VICTA AVIATION DIVISION

SERVICE BULLETIN No. 4

SUBJECT Rudder pedals bearing blocks. Mod. No. B4.

EQUIPMENT AFFECTED Airtourer 100.

Fig. 1 Bearing Block

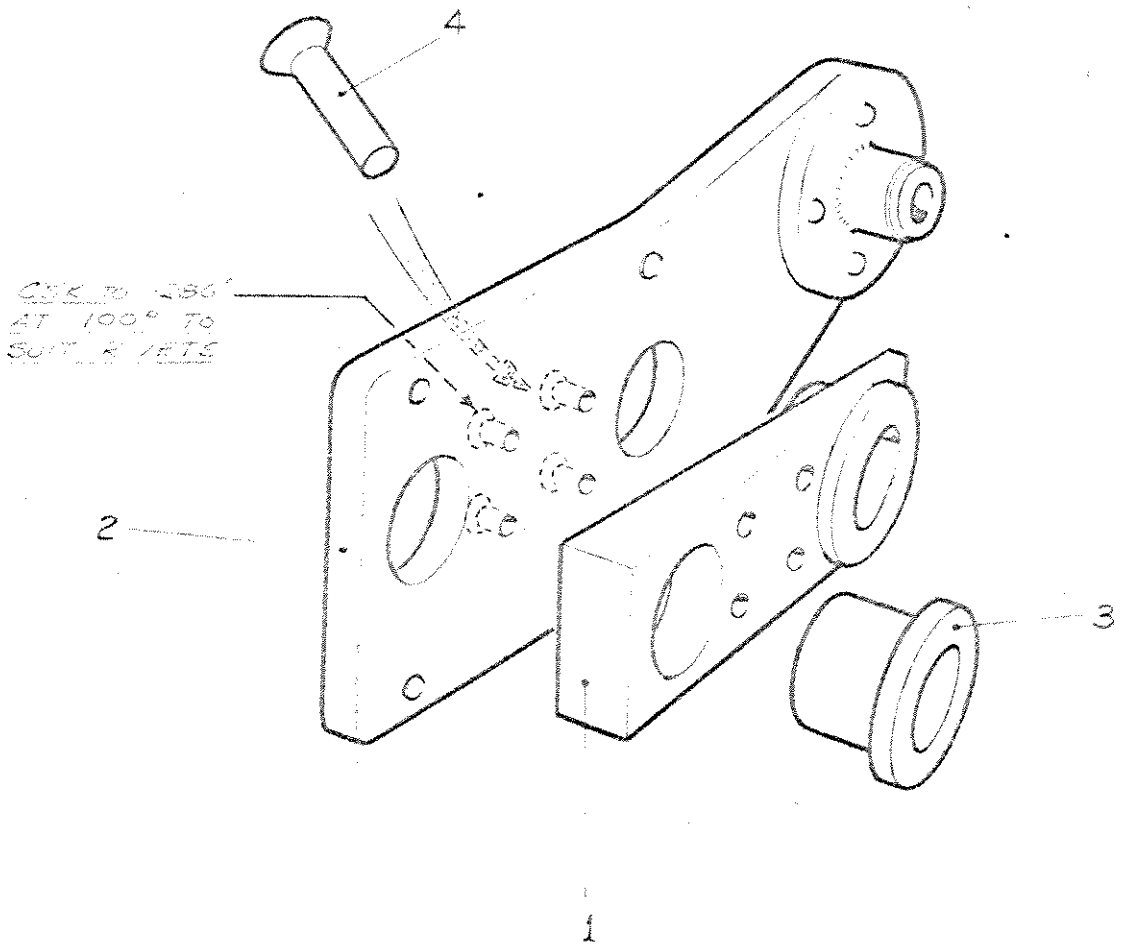
REASON Failure of the rivets in the structure of the bearing blocks has occurred due to excess load being applied in a downward direction on the rudder pedals, thus allowing the rear rudder pedals torque tube to pivot on the forward torque tube bearing.

DETAILS Rectification of the above failure can be achieved by replacing the existing rivets with larger diameter rivets and the existing rear bearing with a longer bearing. Refer to details listed below:

(g) Remove the four self locking nuts and washers securing each bearing block to the inner sides of the fuselage, discard the nuts and withdraw the clevis bolts from the outer sides of the fuselage, thereby freeing the rudder pedal assembly from the fuselage structure.
NOTE: It is only necessary to partially withdraw the clevis bolts. However, if they are fully withdrawn care must be taken to ensure that the tubular spacers between the channel structure remain in position.
